RESOLUTION HOLDING HEARING ON APPEAL OF BRADLEY & BELINDA MC ANINCH (OWNER), REPRESENTED BY BRADLEY MC ANINCH (OFFICER), ON A DENIAL OF TYPE 2 DESIGN ALTERNATIVES FOR A PUBLIC HEARING SITE PLAN FOR PROPERTY LOCATED AT 4700 SOUTHEAST 14TH STREET

STAFF REPORT TO THE PLANNING COMMISSION

Brad's Collision Center - New Facility

A5.1

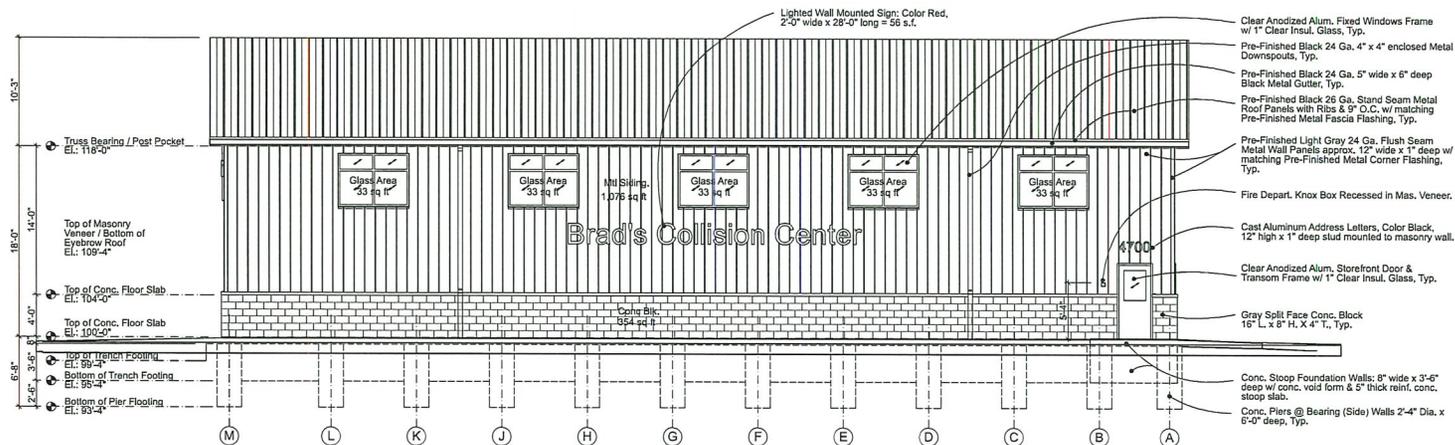
- d. Bradley & Belinda Mc Aninch’s Site Plan includes no transparency proposed within the required 2 feet and 8 feet along the primary façade and the proposed design would not meet the intended commercial character for the corridor.

The proposed building design resembles a typical structure found in an industrial context. A Storefront building would typically include a parapet roof, a mix of major façade materials, a street facing primary entrance, and significant transparency between 2 and 8 feet on a street facing façade. The exterior of the applicant's proposed building would include 24-gauge metal siding and 26-gauge pitched metal roofing with split face concrete blocks around the base of the building on all sides. There is no transparency proposed within the required 2 and 8 feet along the primary

façade. The proposed design would not meet the intended commercial character for the corridor.

Jason Van Essen noted that with the overhead door and lack of transparency, a lot of the same issues would still apply.

Rick Trower questioned the appropriateness of the proposed design for the corridor. Indicated the proposed roof is the least expensive option for a roof. Indicated he had reservations about the project not complying with the transparency requirements and thought the applicant should work with staff on a solution.

Chris Pose, 505 5th Avenue Suite 1005 stated the reason for lack of transparency along the primary façade is due to the robbery and arson that occurred last January. They are providing windows at a higher level to meet the intent of city code but also trying to prevent future theft. This effort would be continued along the north side of the building and would also allow the owner to use the indoor space for bodywork. The owner is trying to provide a more attractive building than the previous one, which has triggered the waivers before the Commission.

1 East (SE 14th Street) Primary Elevation

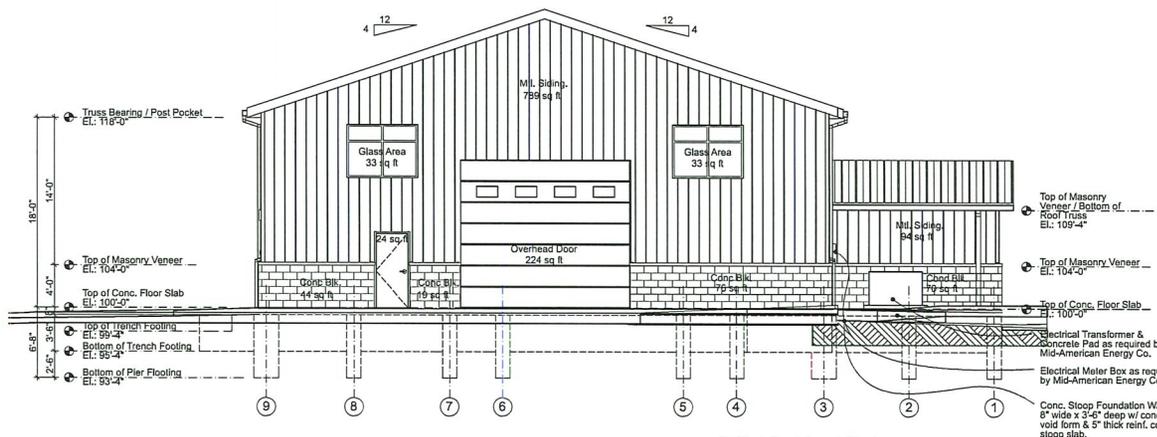
Michael Delp stated SE 14th Street is a mapped primary street and must be treated as a primary street per code requirements.

- d. Bradley & Belinda Mc Aninch's provides the no transparency proposed between 2 feet and 8 feet along the primary façade was to address security and safety concerns, but the Site Plan does include additional transparency at higher levels to address such transparency concerns.
